706 MISSION STREET •
THE MEXICAN MUSEUM AND
RESIDENTIAL TOWER PROJECT

CITY AND COUNTY OF SAN FRANCISCO
PLANNING DEPARTMENT: CASE NO. 2008.1084E

RESPONSES TO COMMENTS

**706 MISSION STREET – THE MEXICAN MUSEUM
AND RESIDENTIAL TOWER PROJECT
DRAFT ENVIRONMENTAL IMPACT REPORT**

FIGURE RTC.1: VIEW K – VIEW TO PROJECT SITE FROM YERBA BUENA GARDENS PEDESTRIAN BRIDGE OVER HOWARD STREET, LOOKING NORTHEAST

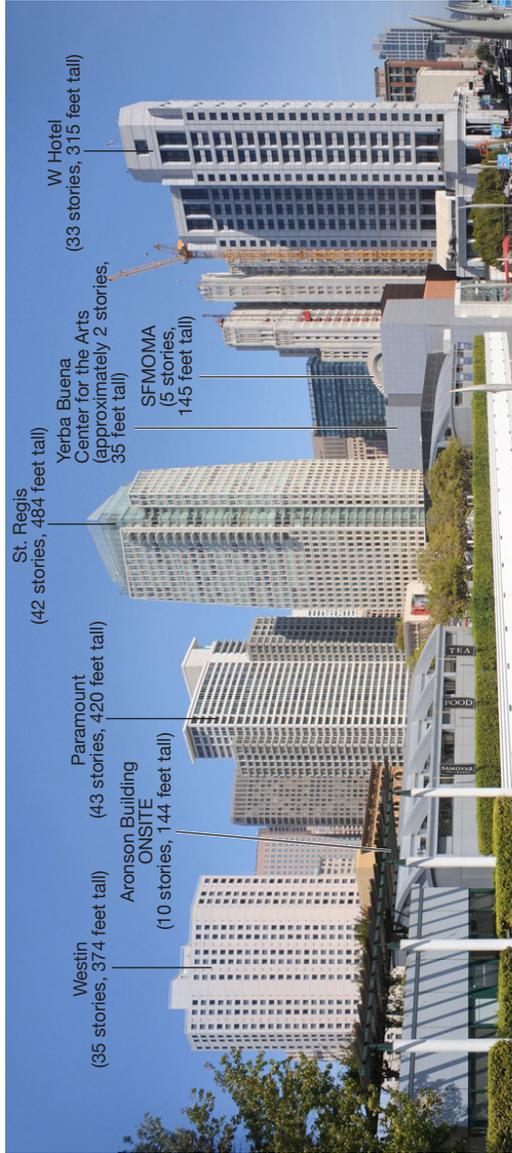
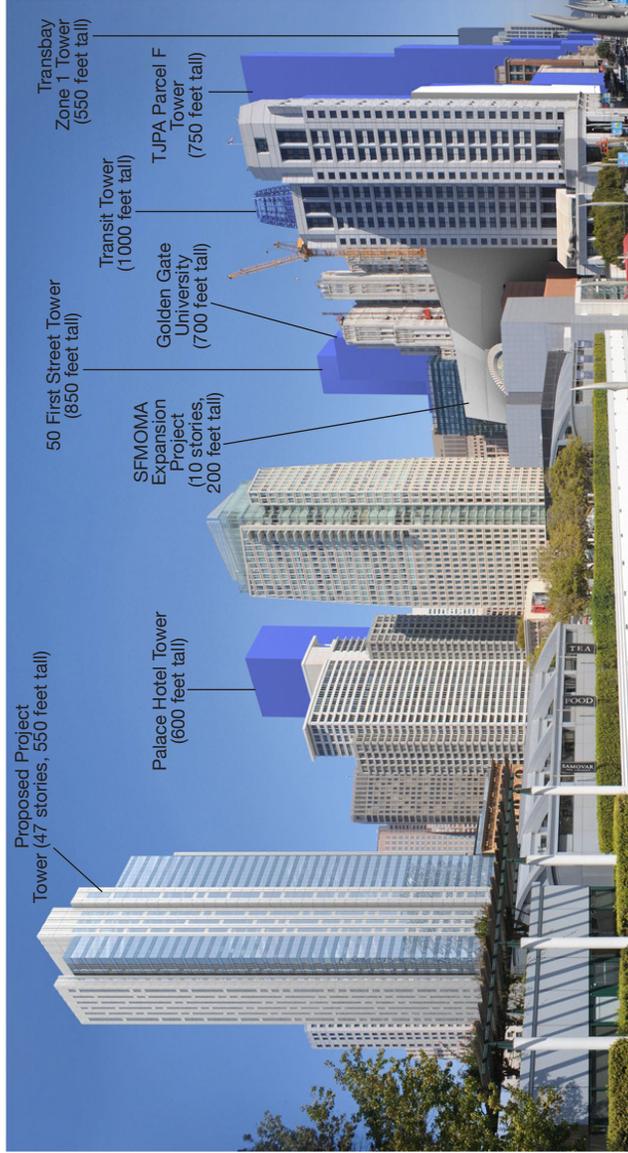
One thing which the EIR unfortunately does not do – and it’s extremely important to me personally – is a visual analysis of other new buildings which are already approved, such as the Museum Tower, which will change the skyline in this area. I think the visual analysis needs to include a view coming from the south of Third Street and take a look at what it looks like with the new Museum Tower and this tall proposed building. (*Commissioner Kathrin Moore, San Francisco Planning Commission*)

And then, finally, what Commissioner Moore brought up, looking at cumulative, looks visually at the expansion of the MOMA and perhaps some visualization with new buildings that we would assume are going to be in place, have already been approved, some of which might be close to going under construction; might be good to at least note that a little bit and see what the appearance looks like when those are in place. (*Commissioner Michael Antonini, San Francisco Planning Commission*)

Comments request that a photosimulation and analysis be provided to address the cumulative visual impact of the proposed project together with nearby approved, but not yet constructed, projects like the San Francisco Museum of Modern Art (SFMOMA) Expansion Project (at 151 Third Street) and potential development allowable under the Transit Center District Plan to the east of the project site. In response to this comment, Figure RTC.1: View to Project Site from Yerba Buena Gardens Pedestrian Bridge over Howard Street, Looking Northeast, is provided to show the proposed project in the context of the development envelope approved for the approximately 200-foot-tall SFMOMA Expansion Project and potential development allowable under the *Transit Center District Plan* (TCDP). This figure is shown on the following page.

Potential development allowable under the TCDP, which was adopted by the San Francisco Board of Supervisors on July 31, 2012, would also be visible in the background to the east of the project site within this view. The approved TCDP is a comprehensive plan and re-zoning of the southern portion of the downtown Financial District, around the site of the Transbay Terminal, and includes most of the approved Transbay Redevelopment Project Area. The TCDP increased height limits to allow for a 1,000-foot-tall Transit Tower (approved) at the former Transbay Terminal site, 700- and 850-foot-tall towers north of Mission Street within specific areas of the existing 550-S Height and Bulk District, and 700- and 750-foot-tall towers along the north side of Howard Street within specific areas of the existing 450-S and 350-S Height and Bulk Districts. Figure RTC.1 shows the proposed project tower with potential development allowable under the TCDP rising from behind existing development in the project vicinity. Shown in this figure are the following potential development projects: a 600-foot-tall tower on the southwest portion of the Palace Hotel site at 2 Montgomery Street; a 700-foot-tall tower at the Golden Gate University site at 536 Mission Street; an 850-foot-tall tower at 50 First Street; a 1,000-foot-tall Transit Tower at 425 Mission Street; a 750-foot-tall tower along the north side of Howard Street (“TJPA Parcel F”); and a 550-foot-tall tower within Transbay Zone 1 near the northwest corner of Howard and Main Streets. Potential development under the TCDP, where visible at all in views of the proposed project, would be viewed in the background and would not be prominent features within the visual setting of the proposed project, given the distance between the project site and these anticipated projects and the scale of existing intervening development which limits visual interaction between the proposed project and these anticipated projects. Under Cumulative conditions, the proposed project would be viewed in the context of a dense and varied downtown high-rise skyline. The proposed project, together with the SFMOMA Expansion Project and potential development under the TCDP, would not make a cumulatively considerable contribution to a significant cumulative impact on visual character and quality.

FIGURE RTC.3: SHADOW ENVELOPE ANALYSIS FOR JESSIE SQUARE WITH PROPOSED PROJECT

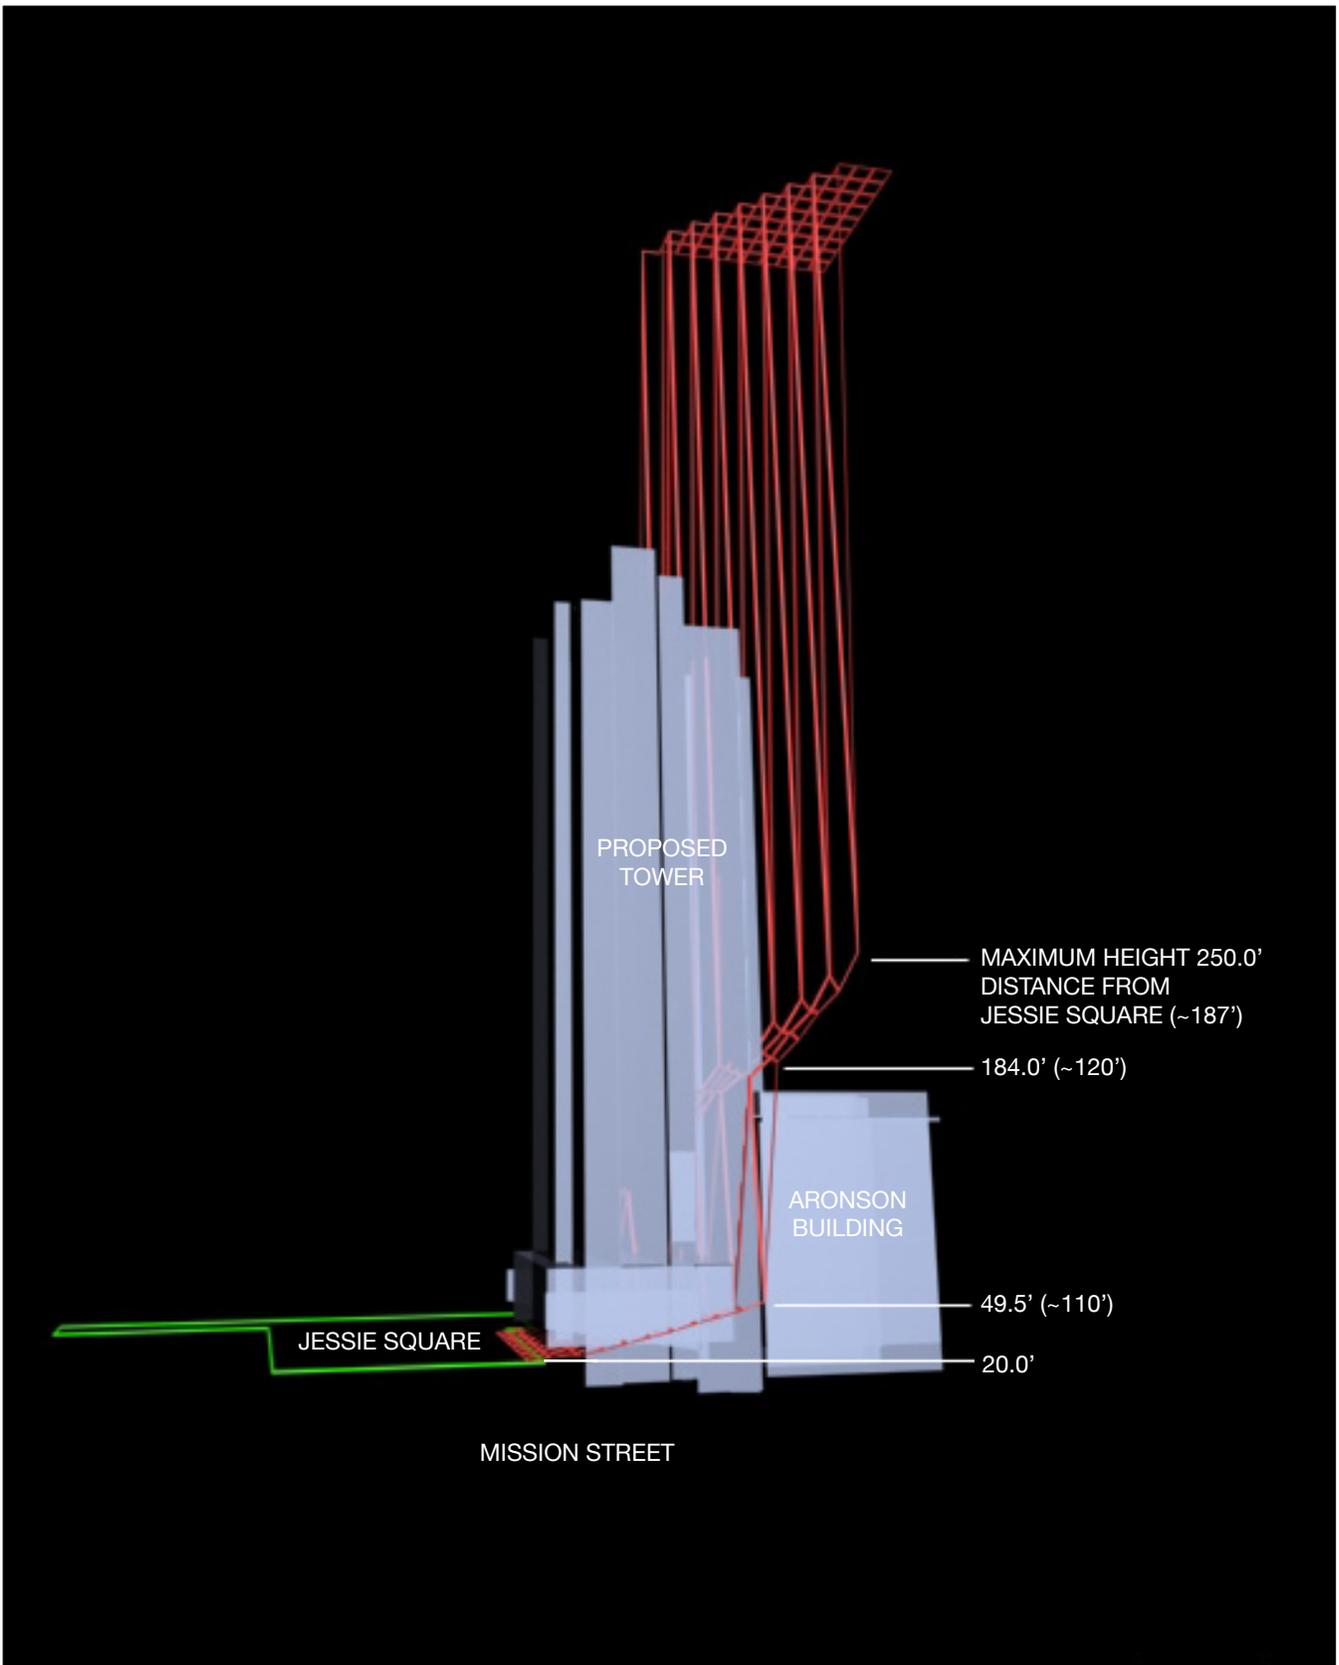
A suggested alternative consisting of a 351-foot-tall elliptical tower that is set back 40 feet from Jessie Square (at the fourth floor and above a podium) would be on the portion of the project site where a building would have to be no taller than 20 feet to 50 feet, depending on its location, in order to avoid casting additional net new shadow on Jessie Square. In this alternative, the tower base would be on the westernmost portion of the project site, and the tower base's proximity to Jessie Square would result in most of the same morning shadows that would be cast by the

Figure RTC.3: Shadow Envelope Analysis for Jessie Square with the Proposed Project, shows the relationship of the proposed project to the shadow envelope. At a height of 550 feet, the proposed tower would be above the red line and would cast net new shadow on Jessie Square if it were constructed on the western two-thirds of the project site. The only location on the project site where the proposed tower could be constructed without casting net new shadow on Jessie Square would be at the eastern end of the project site (above the existing Aronson Building). Constructing the proposed tower in this location would require the demolition of a portion of the interior of the Aronson Building, which was recently designated as a Category I Significant Building in the expanded New Montgomery-Mission-Second Street Conservation District.
